WHY THE COAL FIRED POWER PLANT (CFPP) SHOULD NOT BE ALLOWED IN LAMU

Summary of objection Points By:

Dr. John Musingi PhD (Senior Lecturer and Programme Coordinator Environmental Planning & Management, Department of Geography & Environmental Studies, University of Nairobi. NEMA Registered EIA & EA Lead Expert, Managing Director - Ecolife Consulting Ltd)

Figure 10 Schematic of location of initial ground-level impacts in relation to height of hazardous air pollutant release.

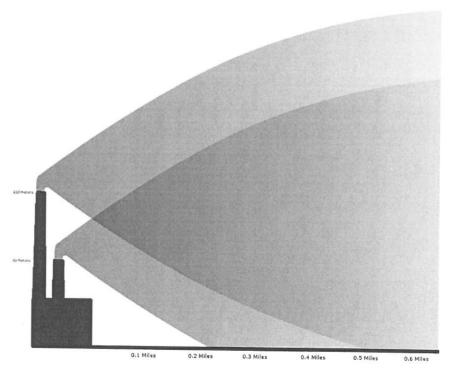
- 5. It is possible the touchdown of these toxic flue gases could be in densely populated areas because the touchdown distance will depend on wind direction and speed the EIA mentions the following vital statistics prevailing wind direction South, average wind speed 3.4 m/s, maximum 10yr 15.5 m/s (See Table 4 -1, site particulars). However the EIA did not explain the implication of these statistics on pollution for example what lies to the south of the site where the impact of the flue gases will be highly felt is towards Mukowe and Lamu Island itself. With the wind speeds provided what will be the touchdown of the flue gases from the stack height? (See Annex 3)
